NONCONFORMANCE REPORT

LIAERICK GENERATING STATION
UNIT 1 & 2 CONTRACT E038
PHILADELPHIA ELECTRIC COMPANY
RADWASTE BUILDING

LIMERICK GENERATING STATION UNITS
 PHILADELPHIA ELECTRIC COMPANY

THIS NCR IS WRITTEN IN RESPONSE TO P.E. Co. AUDIT FINDING # N-093. THE CORRECTIVE ACTION INCLUDED RE-INSPECTION OF A NUMBER OF WELDS, HOWEVER SOME OF THESE WERE FOUND TO BE PERMANENTLY INACCESSIBLE, FOR VARIOUS REASONS, AND ARE DOCUMENTED IN THIS NCR.

41A-116-4

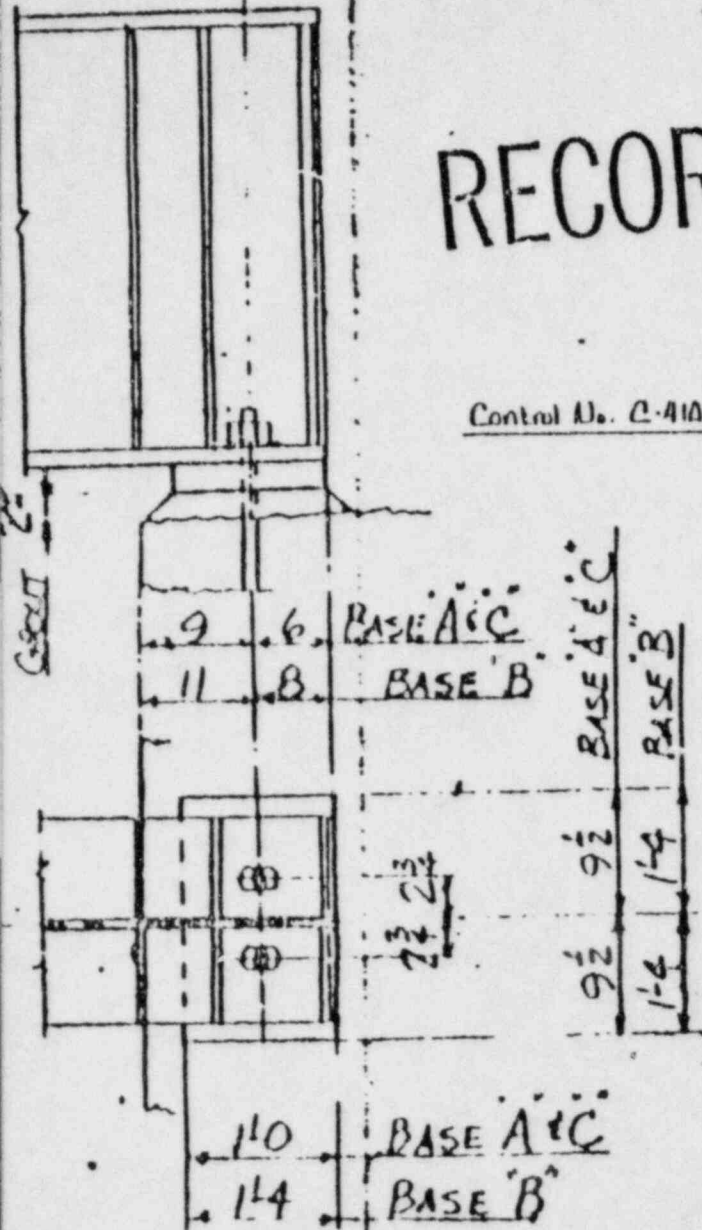
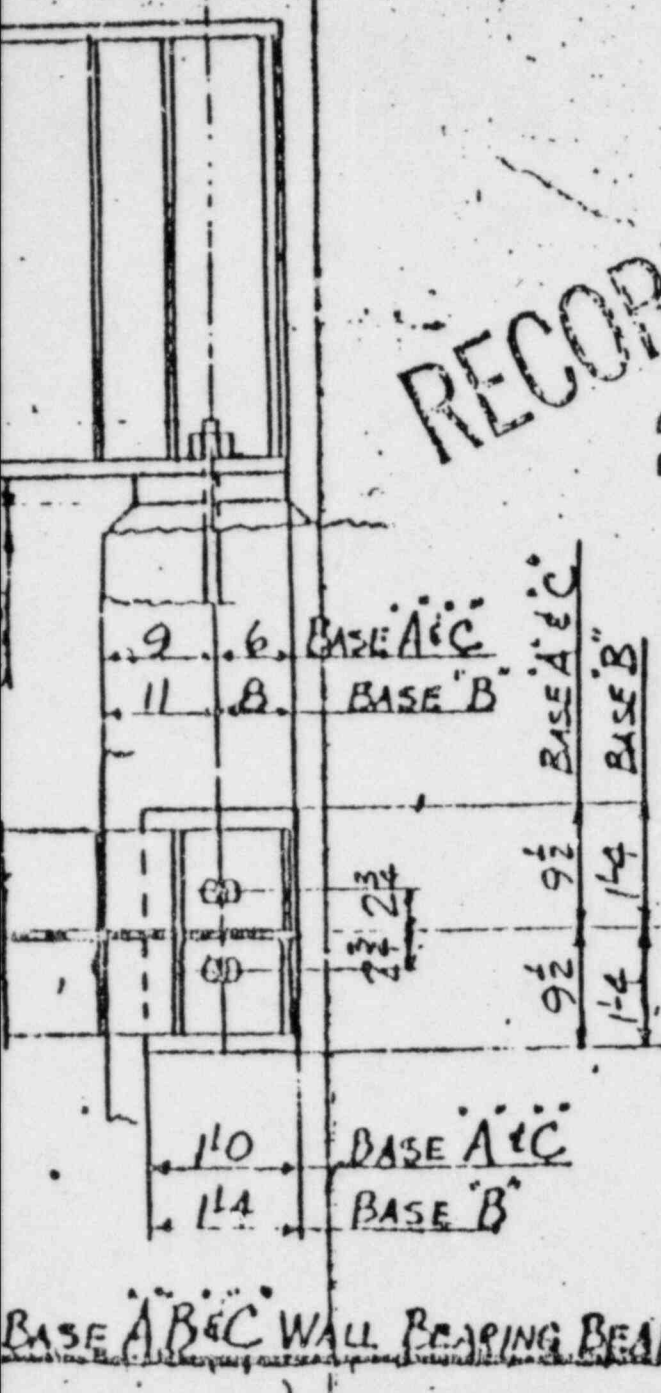
4. ITEM INSPECTED Re-inspection of work in question in Quality Control inspection plan C-543-W-1-5. Hinges to beams fillet welds, beam 127B11 Right hand end, For side to beam 11822, only could inspect 13" of weld remainder in concrete. Beam 127B11 Right hand end, For side to beam 11822, only could inspect 17" of weld remainder in concrete.

4. ITEM INSPECTED Re-inspection of welds in question in Quality Control inspection plan C-41A-116-W-1-1. Angles to columns fillet welds beam 179B8 left hand end along side to column 10302 beam 179B8 right hand end along side to column 10501 beam 179B1 right hand end along far side to column 10502 beam 12727 right hand end along side to column 10301 - 13" only remainder in concrete beam 134B7 left hand end along far side to column 10301 - 9" only on both sides remainder in concrete beam 119B11 right hand end along far side to column 10412 - 14 1/2" only on along side remainder in concrete, (cont)

ITEM 1: RADWASTE BLDG. STR. STEEL ELEV. 191'-0 (Dwg C-543 AND VENDOR PRINT 8031-C41A-116-4, K5944 E3)

13 CLIP ANGLE CONNECTION WELDS WERE INSPECTED, 7 WERE FULLY ACCEPTIBLE, 6 HAD THE UPPER PART OF THE ANGLE EMBEDDED IN SLAB CONCRETE (WITH THE LOWER PORTION ACCEPTIBLE) THE SIX LOCATIONS ARE DESCRIBED ON SHEETS 5 AND 11 OF THIS NCR.

- (1) RADWASTE BLDG. STR. STEEL, ELEV. 191'-0"
BEAMS 127B7, 127B11, 137B2 AND 119B11.
USE AS IS

RATIONALE: PER ENGINEERING ANALYSIS, FILE 41-P,
SHEET NOS. 131 TO 136, VISIBLE WELD IS CAPABLE
OF SUPPORTING DESIGN LOAD.

FIGURE 7

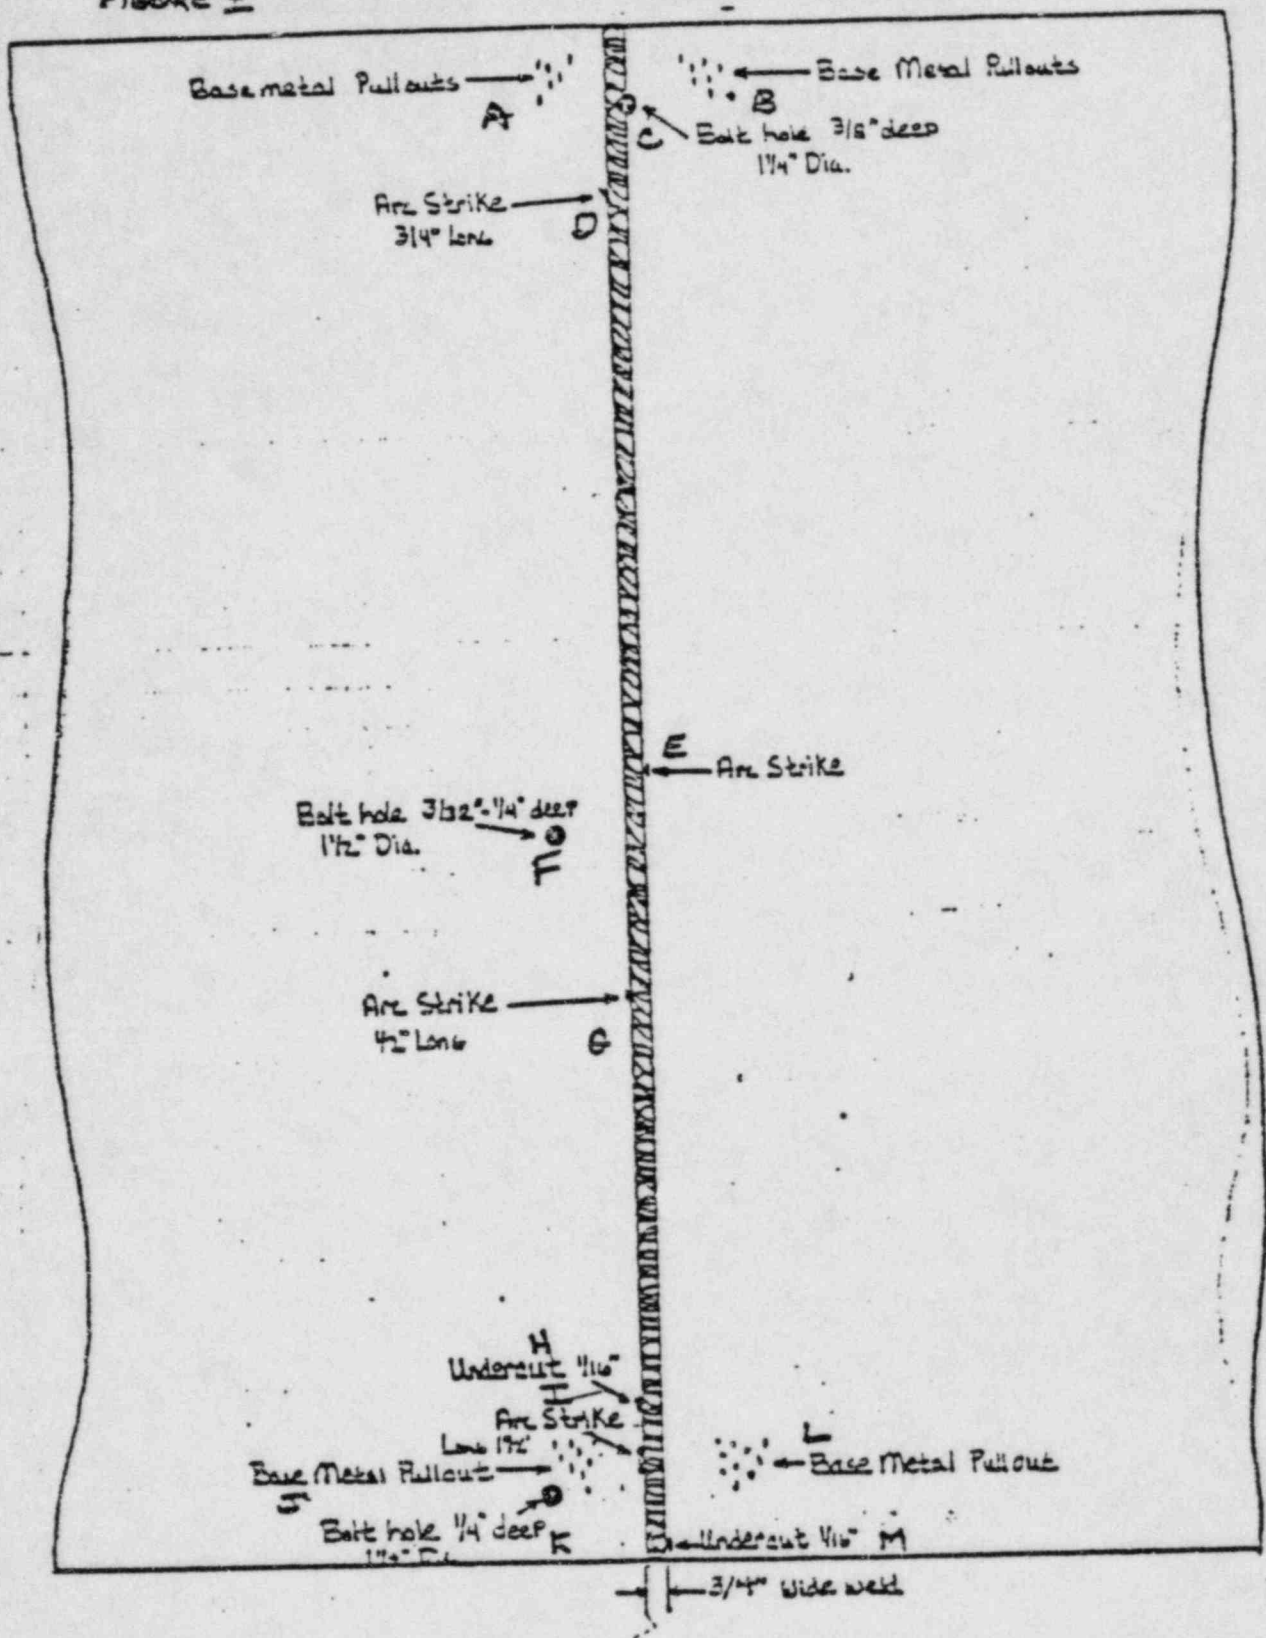
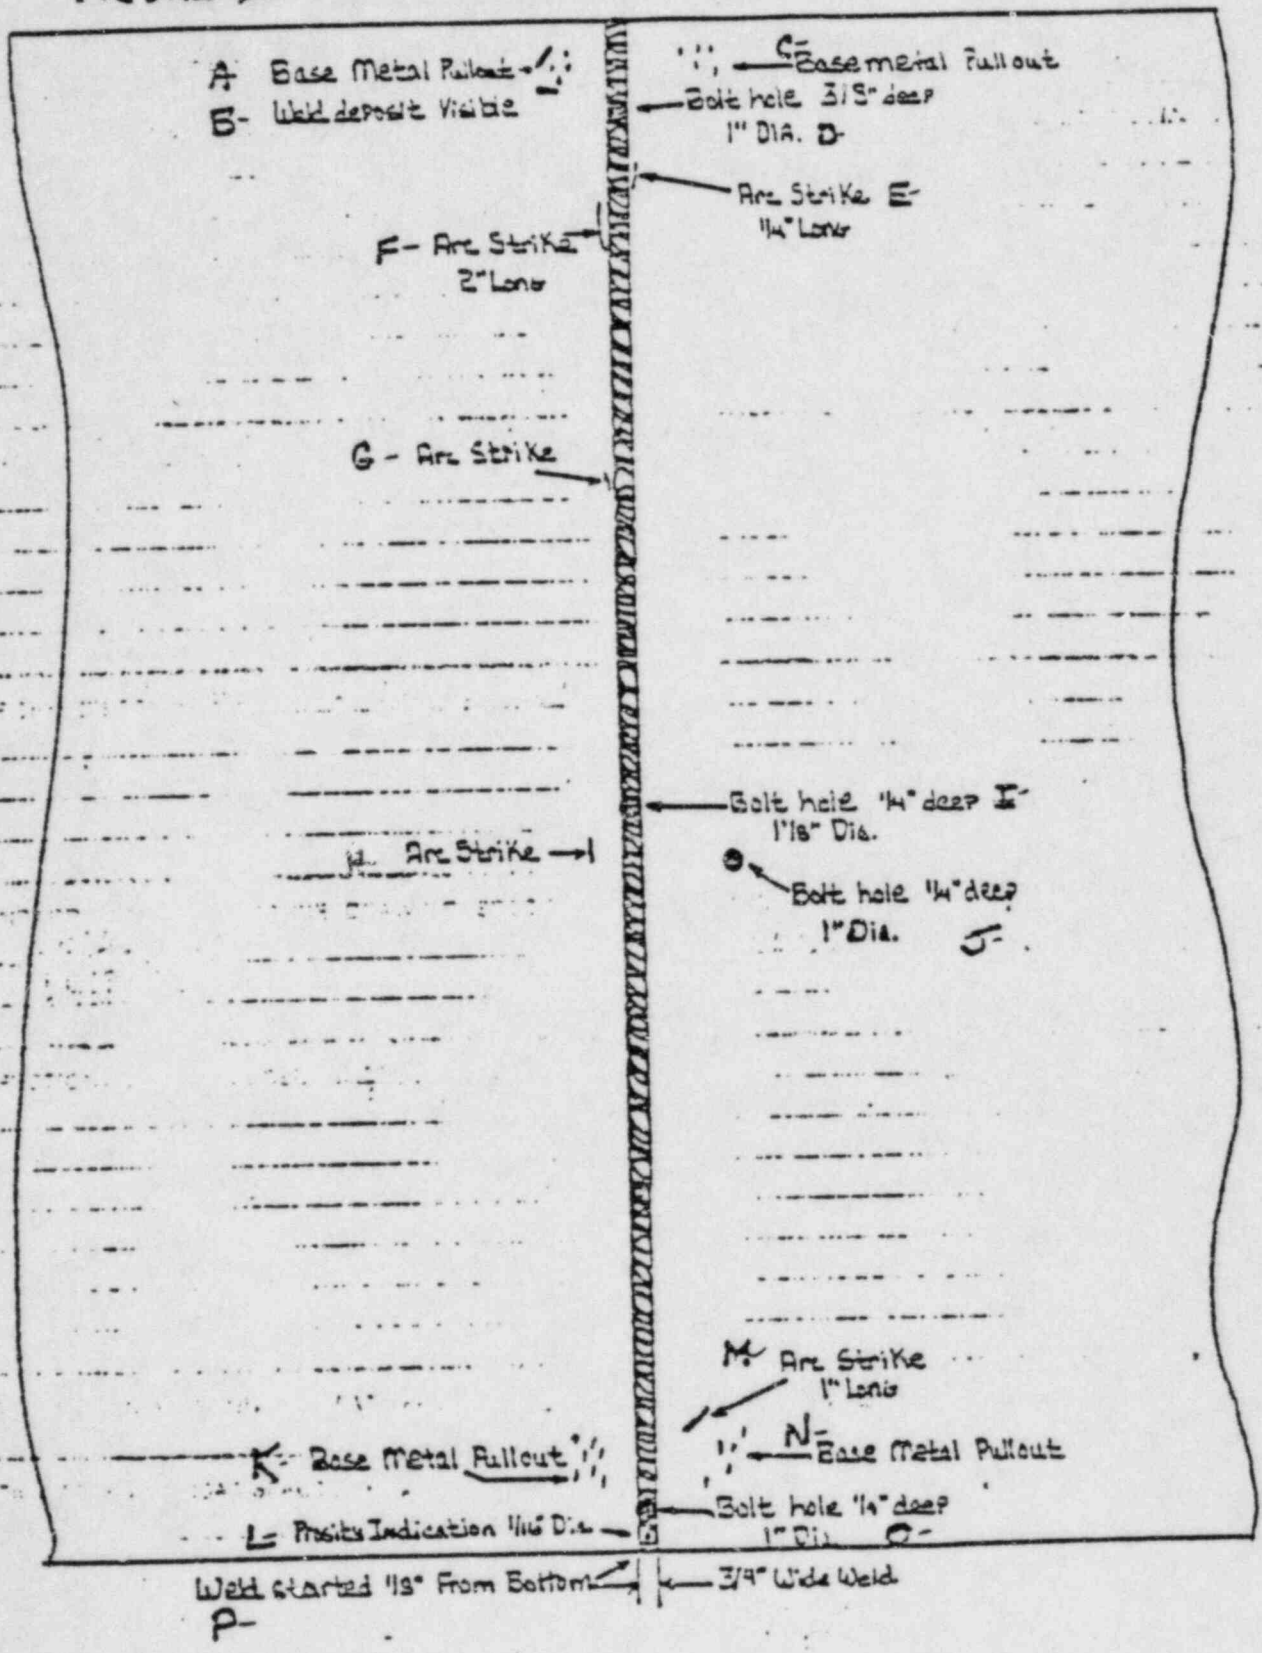
FIGURE 1 EXTENT OF DISCONTINUITIES REPORTED

- ITEM A - BASE METAL PULLOUT $\frac{1}{16}$ " DEEP (PAINTED SURFACE)
- ITEM B - BASE METAL PULLOUT $\frac{1}{16}$ " DEEP (PAINTED SURFACE)
- ITEM C - BOLT HOLE AS REF. ON C-954
- ITEM D - ARC STRIKE $\frac{3}{4}$ " LONG
- ITEM E - ARC STRIKE $\frac{1}{2}$ " LONG
- ITEM F - BOLT HOLE AS REF. ON C-954
- ITEM G - ARC STRIKE $\frac{1}{2}$ " LONG
- ITEM H - UNDERCUT $\frac{1}{8}$ " DEEP
- ITEM I - ARC STRIKE $1\frac{1}{2}$ " LONG
- ITEM J - ROSE METAL PULLOUT $\frac{1}{16}$ " DEEP
- ITEM K - BOLT HOLE AS REF. ON C-954
- ITEM L - BASE METAL PULLOUT $\frac{1}{16}$ " DEEP
- ITEM M - UNDERCUT $\frac{1}{16}$ " DEEP

TABLE 2 EXTENT OF DISCONTINUITIES REPORTED

- ITEM A - BASE METAL PULLOUT $\frac{3}{32}$ " DEEP
- ITEM B - WELD DEPOSIT VISIBLE
- ITEM C - BASE METAL PULLOUT $\frac{3}{16}$ " DEEP
- ITEM D - BOLT HOLE
- ITEM E - ARC STRIKE $\frac{1}{4}$ " LONG
- ITEM F - ARC STRIKE 2" LONG
- ITEM G - ARC STRIKE
- ITEM H - ARC STRIKE
- ITEM I - BOLT HOLE
- ITEM J - BOLT HOLE
- ITEM K - BASE METAL PULLOUT $\frac{3}{16}$ " DEEP
- ITEM L - POROSITY INDICATION $\frac{1}{16}$ " DIA.
- ITEM M - ARC STRIKE 1" LONG
- ITEM N - BASE METAL PULLOUT $\frac{1}{32}$ " DEEP
- ITEM O - BOLT HOLE
- ITEM P - WELD START $\frac{1}{8}$ " FROM BOTTOM OF SEAM

ITEM 5: RPV PEDESTAL UNIT 2 CRD HOUSING SUPPORT EMBED PLATE (DWG C954)

AT SPICE LOCATIONS (90° AND 270°), EMBED PLATE HAS A NUMBER OF DEFICIENCIES DESCRIBED ON SHEETS 3, 4, 14, 15, AND 16 OF THIS NCR. NO BACKING BAR WAS USED FOR THE SPICE WELDS (AS DETERMINED FROM THE TOP OF THE PEDESTAL CONSTR. J-1) AND THE BACK SIDE OF THE PLATE IS INACCESSIBLE FOR INSPECTION.

5) RPV PEDESTAL, UNIT 2, CRD HOUSING SUPPORT EMBED PLATE (DWG. C-954 & G.E. DWG. 761 & 724 SHTS 1 & 2)

USE AS IS - RATIONALE:

(9) DEFICIENCIES DESCRIBED ON SHEETS 3, 4, 14, 15 & 16. BASED ON ENGINEERING EVALUATIONS, THESE KINDS

(5) CONT'D. OF IMPERFECTIONS WILL NOT AFFECT THE STRUCTURAL INTEGRITY OF THE 3/4" THICK PLATES.

(b) BACKING BAR NOT USED FOR SPLICE WELDS
 SPLICE WELDS WERE NOT DESIGNED & NOT REQUIRE FOR STRUCTURAL SUPPORTS. SPLICE WELDS WERE PROVIDED AT LOCATIONS 90° & 270° TO FORM A CONTINUOUS BACKING FOR CONCRETE POUR.
